**BEFORE THE NATIONAL GREEN TRIBUNAL
PRINCIPAL BENCH, NEW DELHI
ORIGINAL APPLICATION NO. 220 OF 2019**

**REPLY ON BEHALF OF THE RESPONDENT NO. 1/ M/S CL GUPTA
EXPORTS PVT LTD, TO THE COMPLIANCE REPORT IN THE MATTER
OF O.A. NO. 220/2019, TITLED AS ADIL ANSARI VS. M/S C.L. GUPTA
EXPORTS PVT. LTD. & ORS. IN COMPLIANCE TO THE HON'BLE NGT
ORDERS DATED 06.08.2020 AND 03.12.2020.**

ANNEXURE-A-2 (copy)

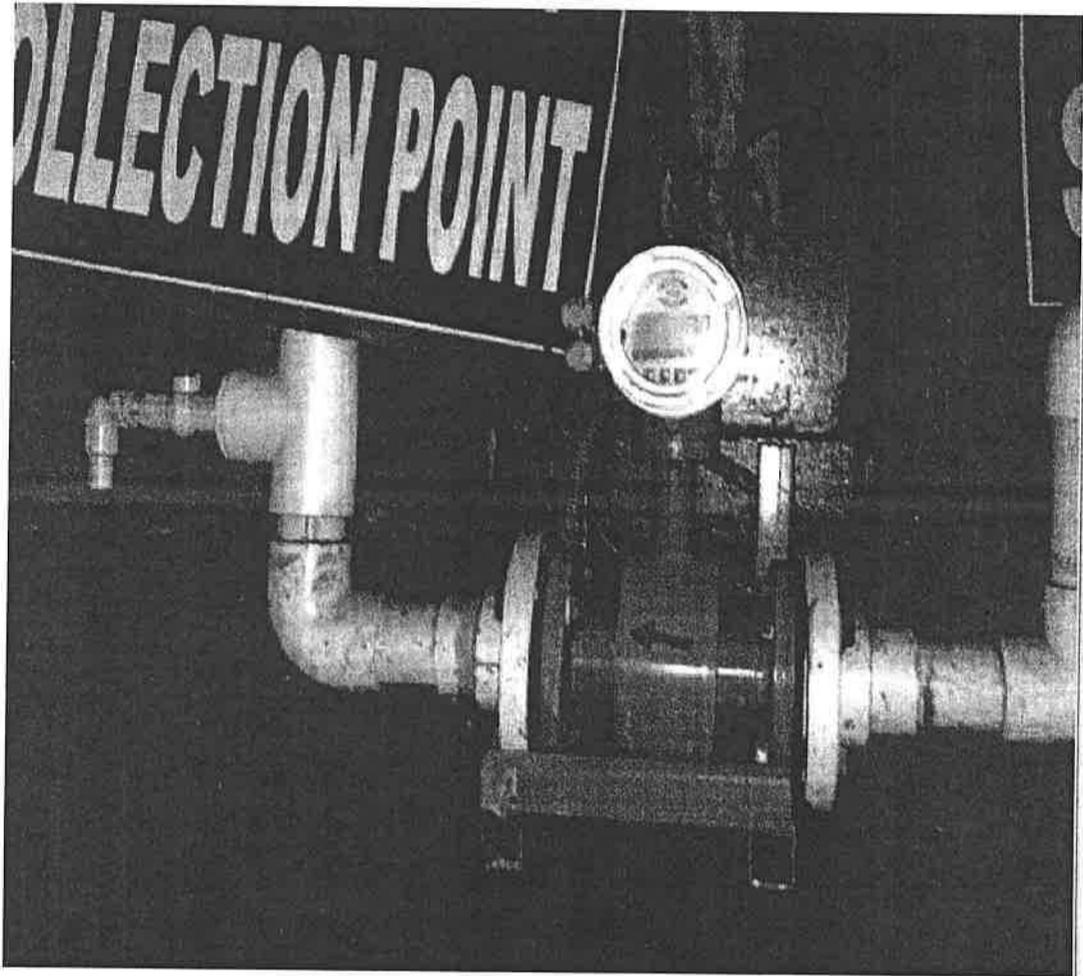
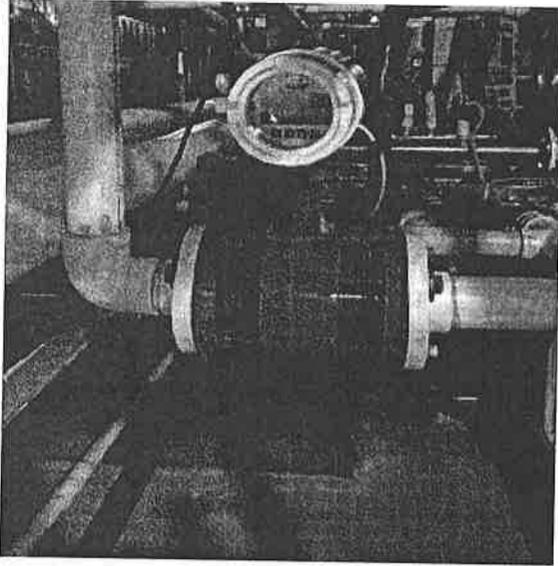
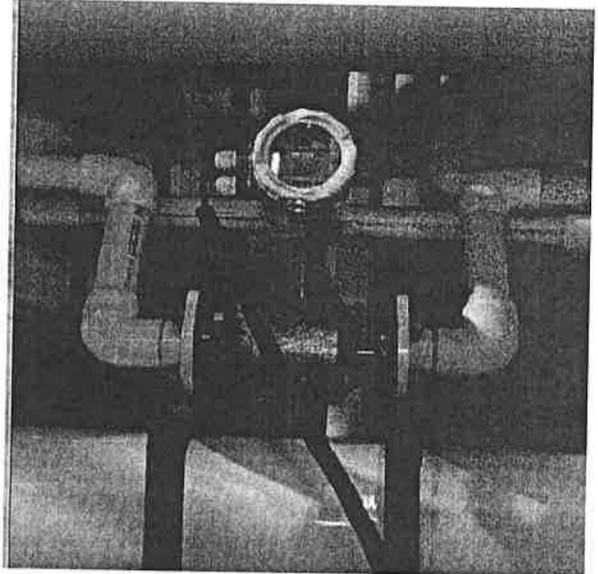
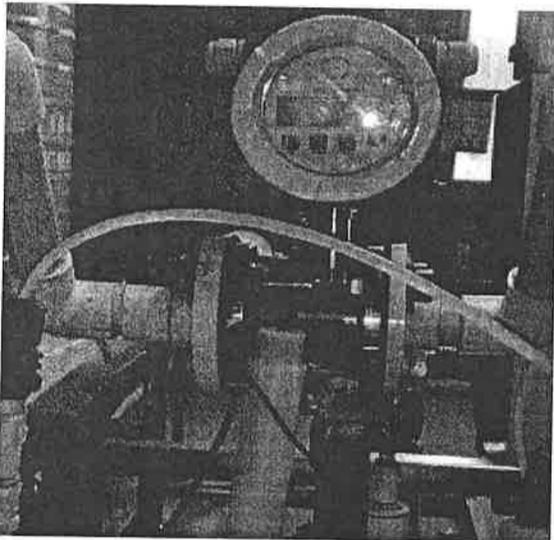
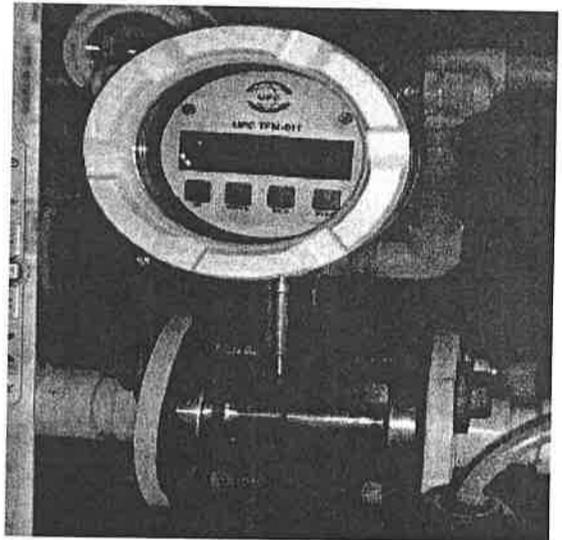
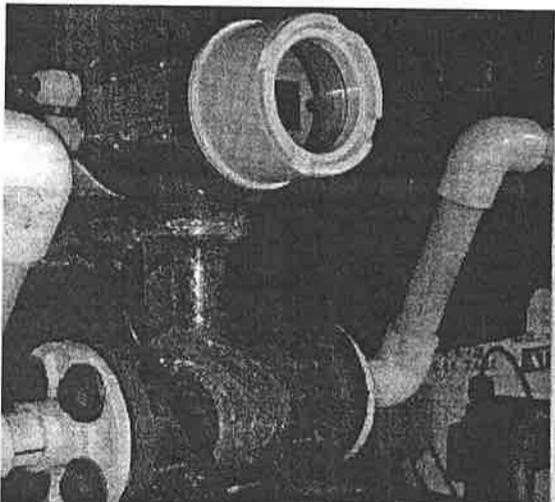
6)	For common-ETP, the unit shall install flow meters at outlet of secondary biological treatment system, permeate of RO, MEE condensate and ATFD condensate.	Unit has already installed the flow meter at outlet of secondary biological treatment system, Permeate of RO, MEE condensate and ATFD condensate. Copy of the photograph confirming the same is annexed herewith as Annexure-A2 (COLLY) .

ANNEXURE-A3

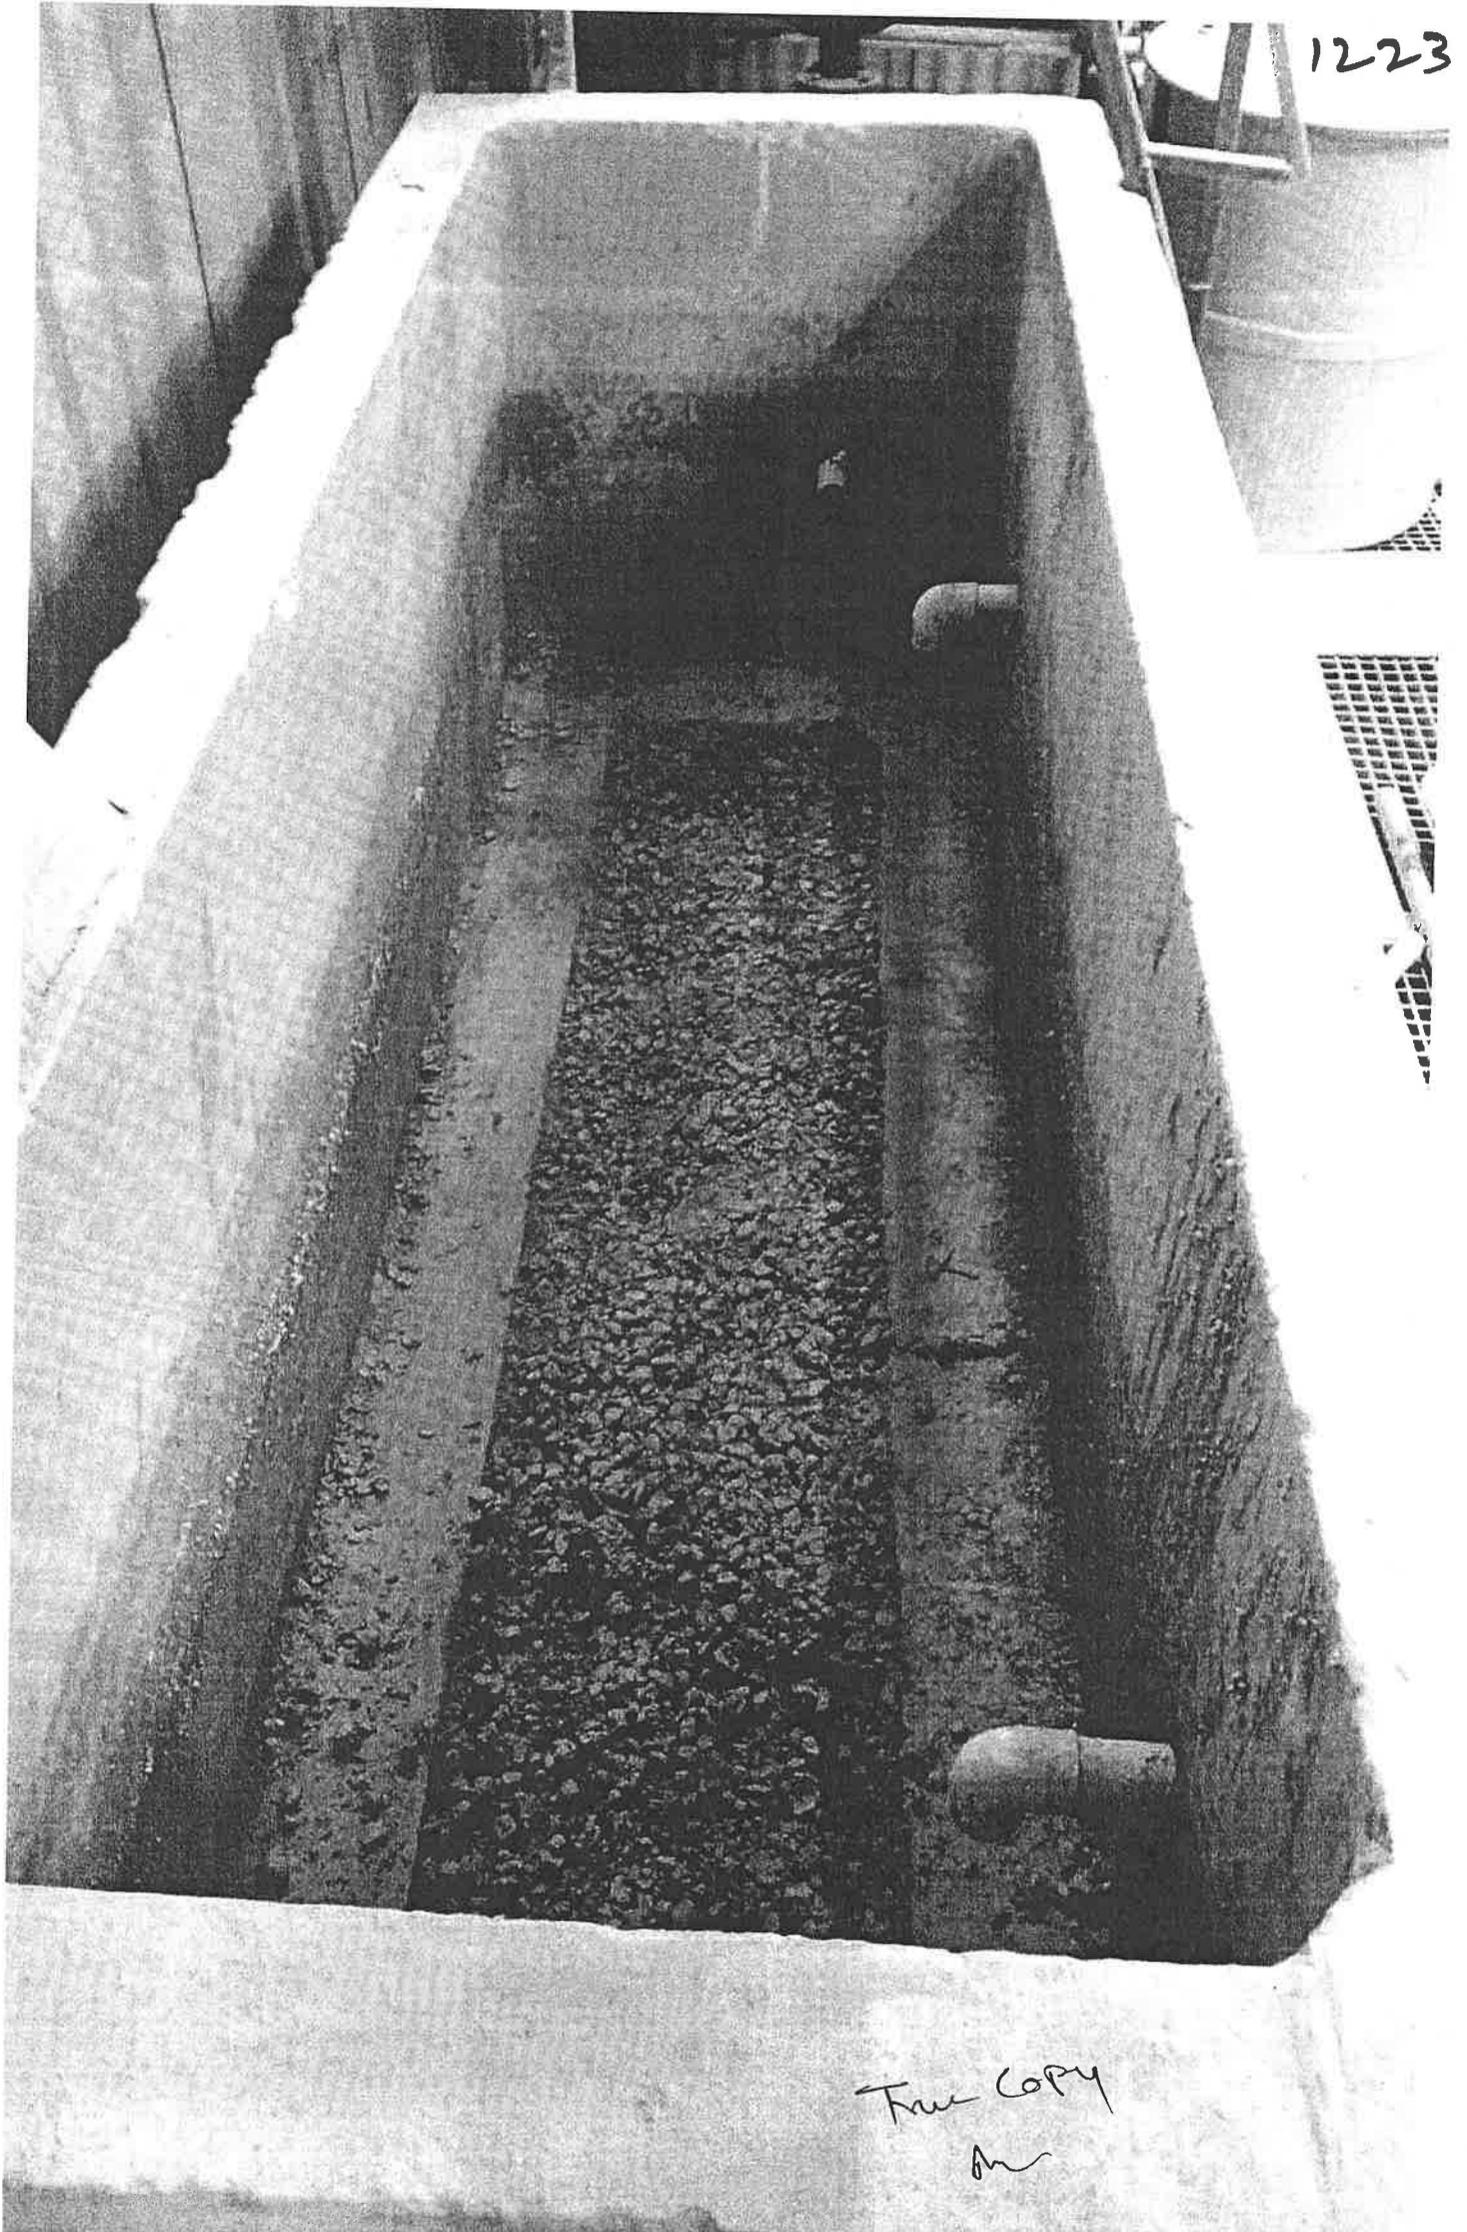
7)	The unit shall dispose off the sludge from sludge drying bed of the previous ETP at wooden art ware manufacturing division, to TSDF site.	This has been undertaken. Copy of the photograph confirming the same is annexed herewith as Annexure-A3 . The sludge being mentioned here was kept for drying naturally on the date of the joint team inspection. The sludge drying bed has been cleaned and sludge has been sent to sludge storage room, thereafter.

CHLORINATION AT STP

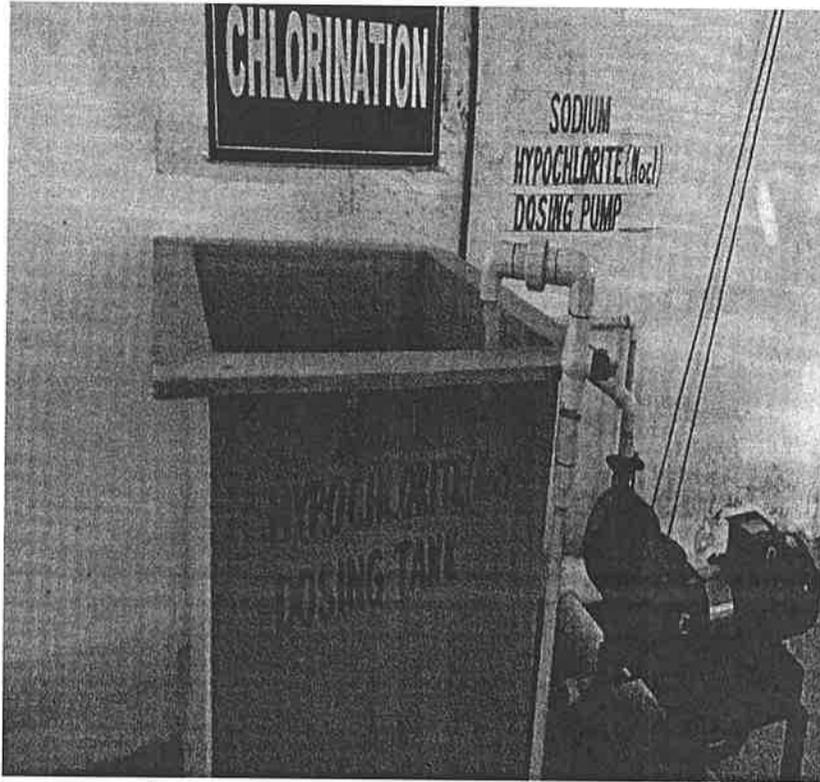
10	The quality of treated sewage is non-complying w.r.t. on land discharge norms w.r.t. pH-5.9 against 6.5 to 8.5. The pH needs to be brought within permissible limit of 6.5 to 8.5; for use in horticulture.	This is already being undertaken and the unit will continue monitoring the same. The unit has installed auto pH correction system to maintain pH in range 6.5 to 7.5 at outlet of STP. The unit has also installed chlorination system for controlling FC concentration below 1000MPN/100ml. Copy of the photograph confirming the same is annexed herewith as Annexure-A4.
